An Appraisal of Flood Risk Modelling for Land at Brackenway, Formby

Updated Model Review Report

December 2015

Sefton Council

Figure 2-1 Modelled Inflow Boundary Comparison

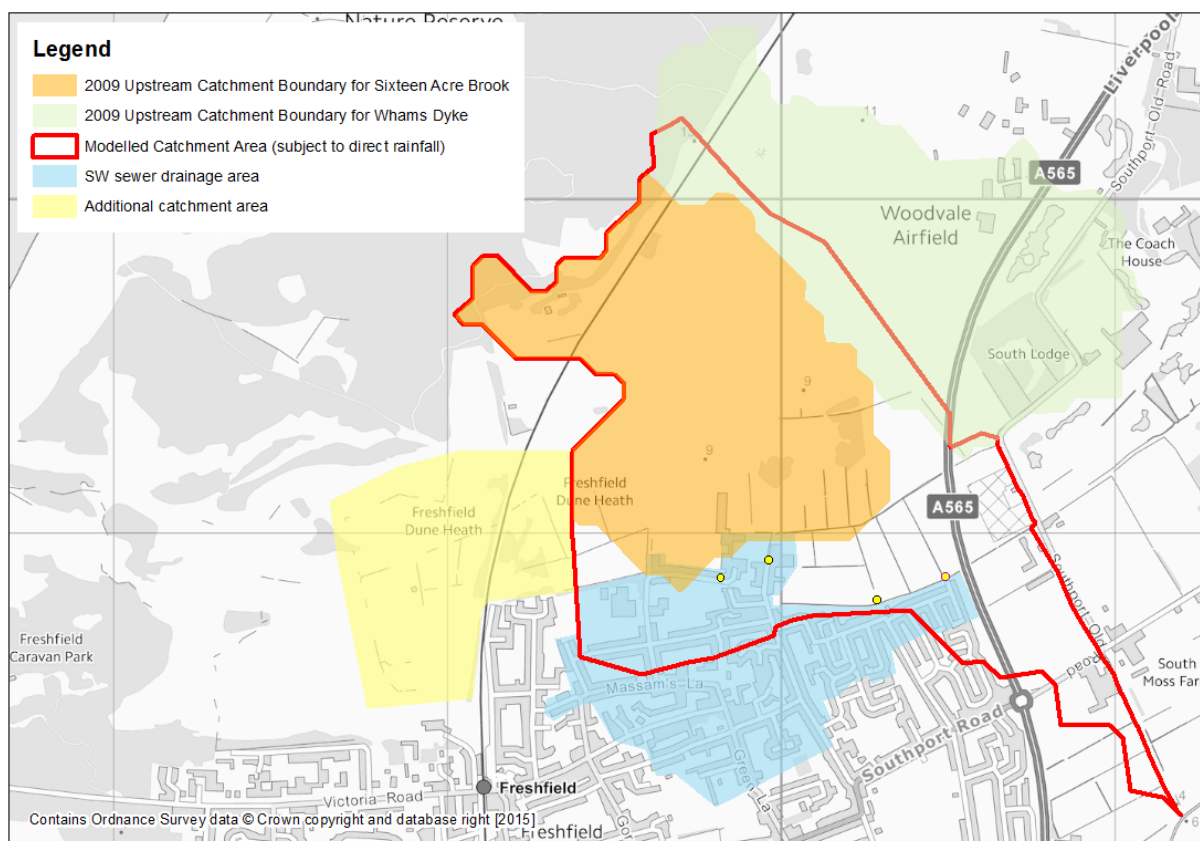
Figure 2-1 shows that whilst the modelled catchment area corresponds well to the original upstream catchment boundary derived for Sixteen/Eight Acre Brook, there is some deviation with the upstream catchment boundary previously delineated for Whams Dyke. Assessment of the underlying sewer network has found that a significant proportion of the sewer network drainage area is not included within the catchment polygon delineated and there may be some additional catchment area draining towards to the site from west.

The comparison indicates that the modelled catchment inflow area draining towards the site may be underestimated and this may affect overland flow pathways, flows and resultant predicted water levels. JBA understand that this catchment boundary was taken from the earlier SWMP study but recommend that this is reviewed further and verified against available datasets (including UU sewer network and LiDAR data) to provide greater evidence that the modelled catchment area is correct and not underestimated. Additional sensitivity testing could be undertaken to assess the impact of a larger catchment inflow area on predicted peak water levels within the site.

Figure 2-2 1 in 100 year plus climate change modelled water levels and outfall levels at the surface water outfall at Hawkesworth Drive (HD)

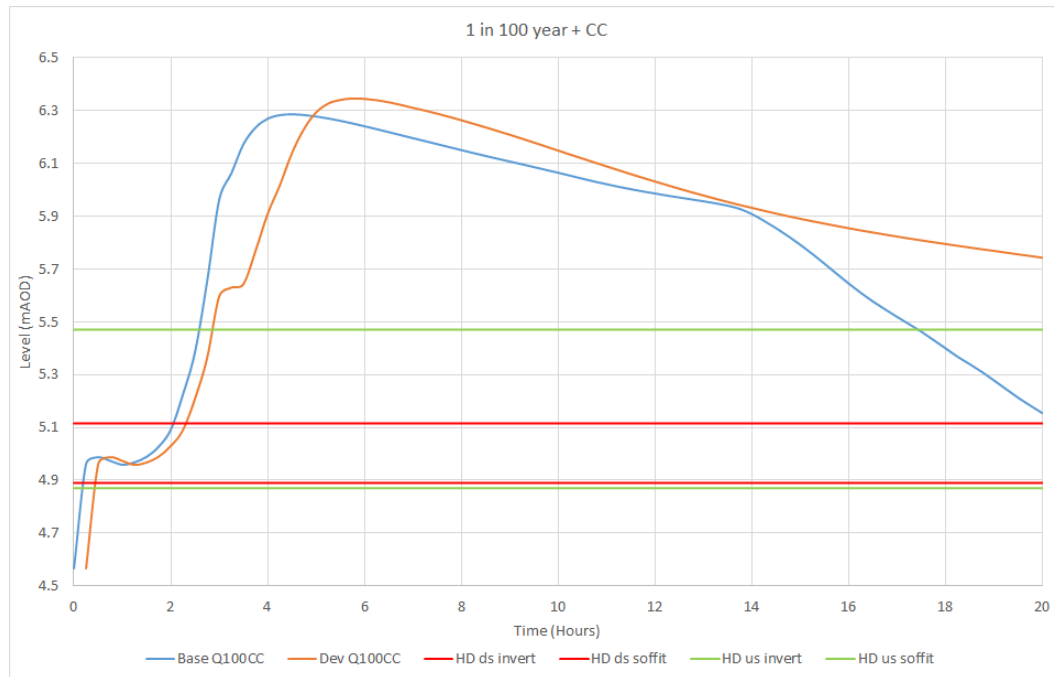
As documented in Section 2.2, the local surface water network has not been modelled and hence the impacts on the surface water system cannot be directly assessed. Instead probable impacts have been reported in a qualitative way. As part of this review, predicted pre and post development water levels at cross section ACR0198.2 (the cross section nearest to Hawkesworth Drive) have been compared to help understand the likely impacts. These comparisons illustrate that for the 1 in 5 year design event, the hydrograph peak and the duration of surface water outfall locking are reduced in the post development scenario. However, for the 1 in 10, 1 in 25, 1 in 50, 1 in 75 and 1 in 100 year events, although the hydrograph peak is reduced in the post development scenario, the duration of outfall locking is shown to be greater. The 1 in 100 year plus climate change and 1 in 1000 year events indicate both a higher peak water levels and a longer duration of outfall locking in the post development scenario. The analysis undertaken indicates that there is unlikely to be any improvement to the surface water flood risk at Hawkesworth Drive as a result of the proposed development, and that local flood risk may in fact increase because of the increased duration of locking of the system. If development at the site is to be progressed, JBA recommend that further more detailed representation / modelling of the local surface water system is

undertaken and integrated into the existing model to fully understand the impacts of the development. This should be informed by a new survey of local drainage network (A11).

Figure 3-1 Predicted Flow Hydrographs at the Formby Bypass Culvert on Eight Acre Brook & Whams Dyke

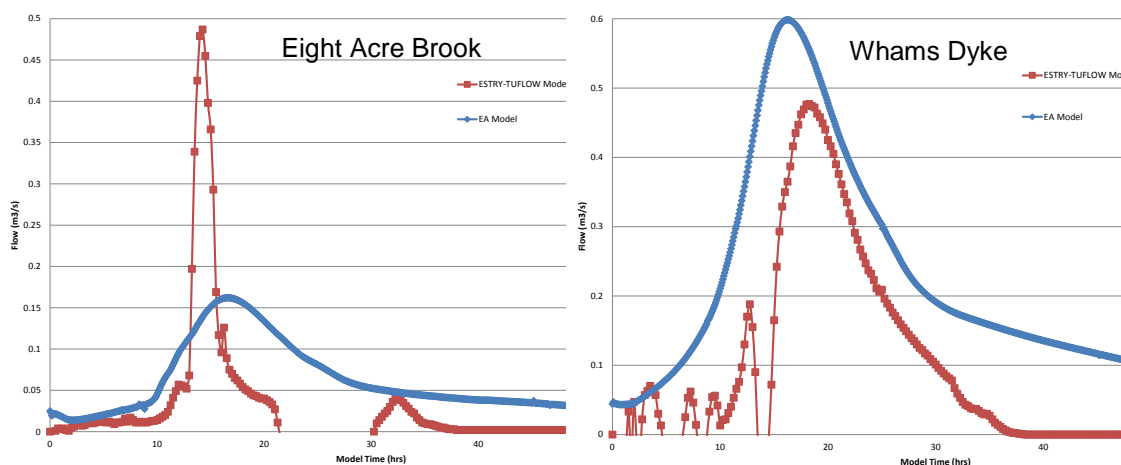
Using the outputs from the critical storm duration test for the 24hr storm duration, a check for consistency was made against the outputs of the Environment Agency's Lower Alt model; also run with a 24hr storm duration. A comparison of the predicted hydrographs on Eight Acre Brook and Whams Dyke for the 1% AEP event at the culverts under Formby bypass are shown in Figure 3-1. These plots highlight some difference in peak flow between models which is inevitable because of the varying hydrological methods used by the models. The Environment Agency model uses a point based inflow hydrograph from a scaled version of ReFH, compared to the direct rainfall applied and the predicted flow routing within the ESTRY-TUFLOW model of the Brackenway site.

Figure 3-3 Predicted 1%CC AEP Event Water Levels at Node ACR0198.1 on Eight Acre Brook

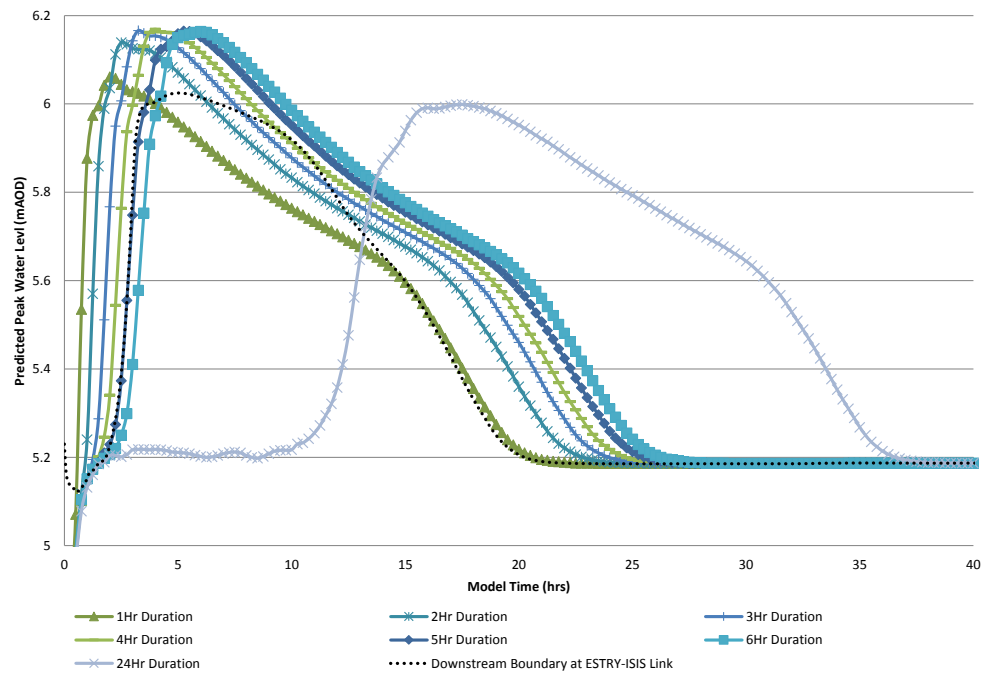
The outputs provided from these model runs are shown graphically in Figures 3-2 and Figure 3-3 and are summarised in Table 3-2. This evidence supports the adoption of the 5 hour storm as the critical duration for the fluvial system.

Figure 3-4 Pre and Post Development Boundary Conditions used within the InfoWorks CS Model

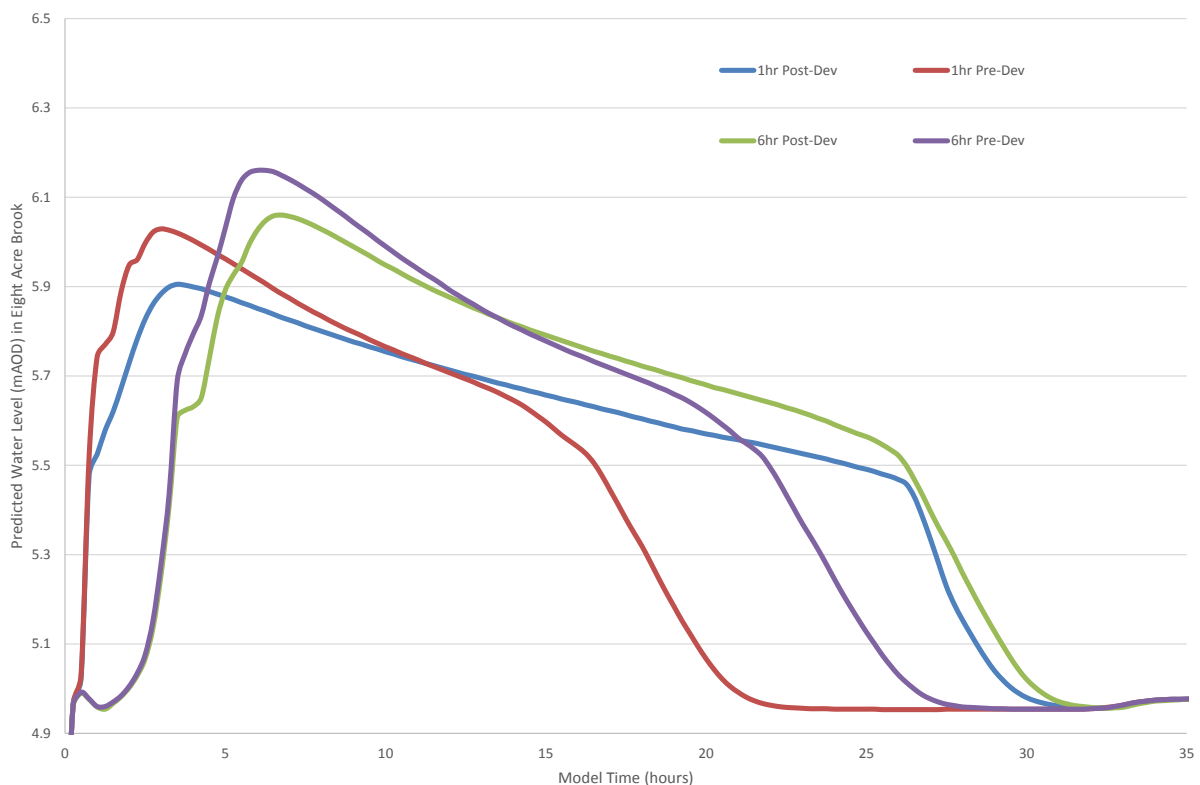
Within the HT boundary, time varying river levels as predicted by the ESTRY-TUFLOW model, for specific events and storm durations have been applied for the pre and post development scenarios. The pre and post development boundary conditions used within the model are illustrated in Figure 3-4.

Figure 3-5 Manholes with a Predicted Reduction in Peak Water Level in the 1% AEP 6 Hour Storm Event

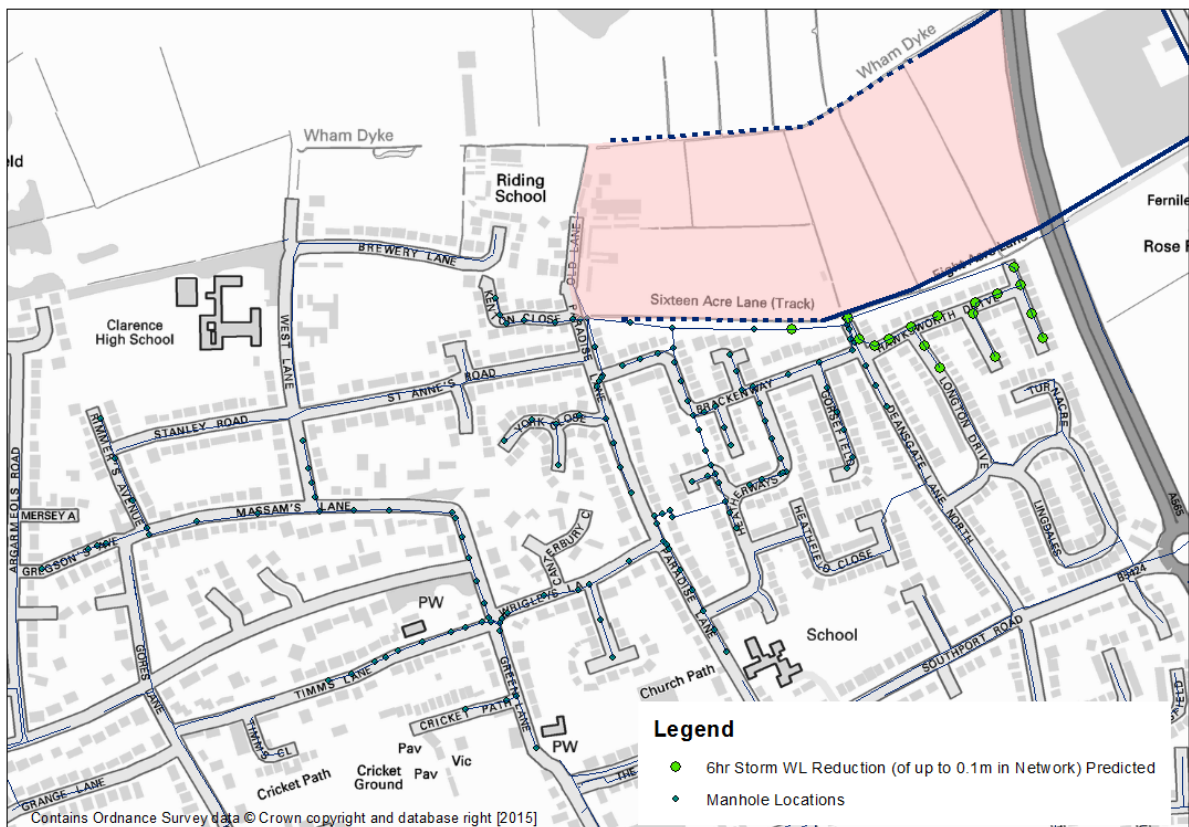
As illustrated in Figure 3-5, there are 17 manholes in the vicinity of Hawkesworth Drive where a reduction in peak water levels within the network (of up to 0.11m) is predicted for the 6hr storm. These manholes are not predicted to flood within the model, but they do demonstrate a local increase in available flood storage within the network in the post development case, relative to the pre-development case for the 6hr storm. Predicted peak water levels in this area for the 1hr storm remain unchanged between the pre and post development cases, indicating that this reduction is dependent on storm duration.
